TO: Anthony Turowski, P.E, District 6 Deputy Director
ATTENTION: Jessica Ormeroid, P.E., Transportation Engineer
FROM: Adam H. Koenig, P.E, Administrator, Office of Roadway Engineering
BY: Gary L. Harrington, P.E., Traffic Studies Engineer, Office of Roadway Engineering
DATE: March 13, 2023
SUBJECT: FRA-670-3.75 (at 4th Street), No PID

The study meets ODOT requirements for an Interchange Operations Study (IOS) and therefore is approved.

No-Build WB I-670 & 4th Street Exit Ramp

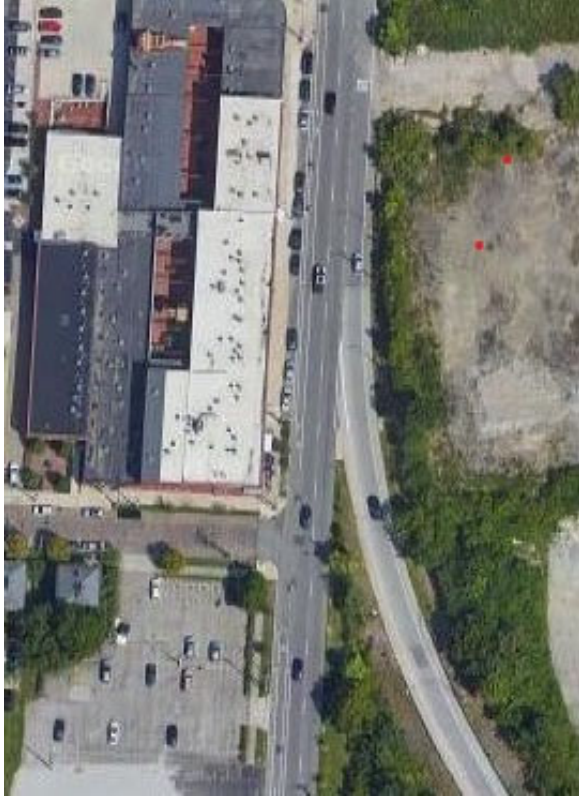
Multiple locations on I-670 WB and 4th Street have failing traffic operations (LOS F); however, the No-Build and Build conditions operate similarly. The proposed improvements help to ensure queuing from the I-670 WB off-ramp to 4th Street do not extend to mainline. Improvements to I-670 WB will be required in the future.
